823 Portsmouth Bypass

Additional Studies

February 9, 2006

State of Ohio
 Department of Transportation
 SCI-823-0.00 PID 19415
 City of Portsmouth, Scioto County

CATCHMENT OPTION DETAILS

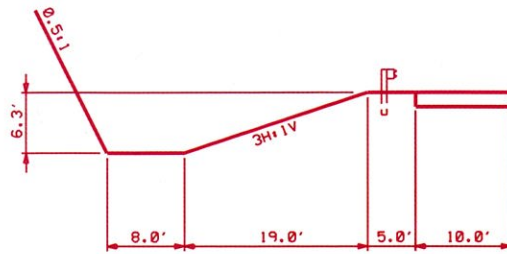
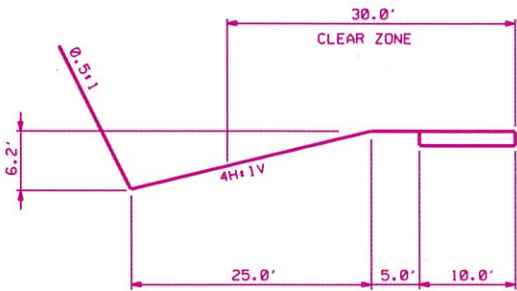
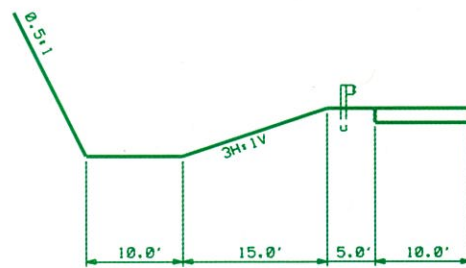
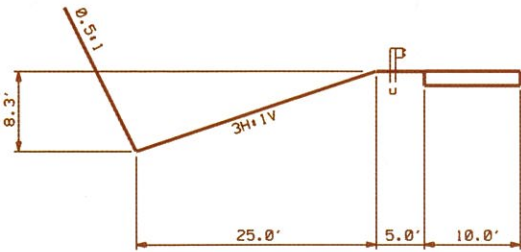
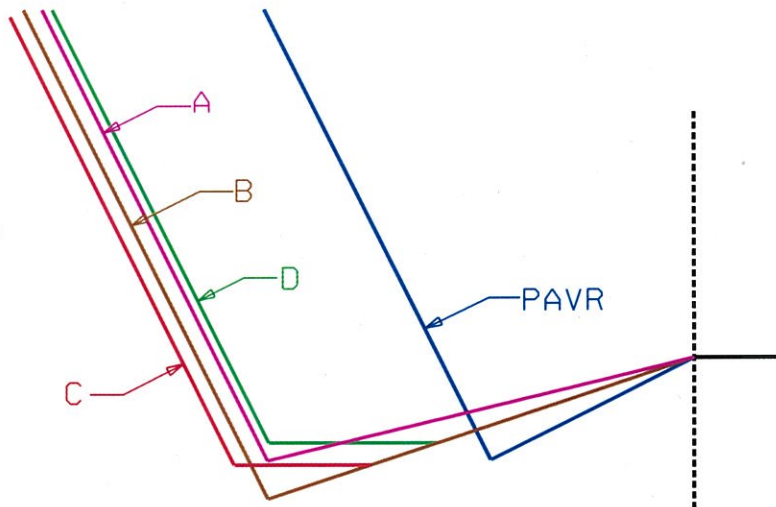
The rock catchment designs were discussed. Dirk's main concern is with accumulation of rock within the clear zone and liability with timely removal. He indicated Option A in OGE's IOC dated 8/8/05 could be considered if the foreslope is flattened to 6:1 (safety grading), thus likely increasing the required width of the ditch. The analysis needs to be verified. Option B and C are ok since there is guardrail protection.

DLZ presented the results from the CRSP analysis for two cut locations (136' and 157' heights). The results were discussed and how they relate to the GB-3 requirements. OGE agreed that the CRSP underestimates the catchment width as indicated in the Oregon study. The values presented in GB-3 Table C are conservative and the designer should run CSRP to verify these values.

1. TSC will update the cost for the 40' median option to include 2 lines of cable barrier and maintenance costs.
2. Another concrete median option will be developed to provide 65 mph SSD at the two curve locations.
3. Assess the rock catchment option A with 6:1 foreslopes.
4. Confirm the percent of rock captured by Options A,B and C as well as the PAVR design.
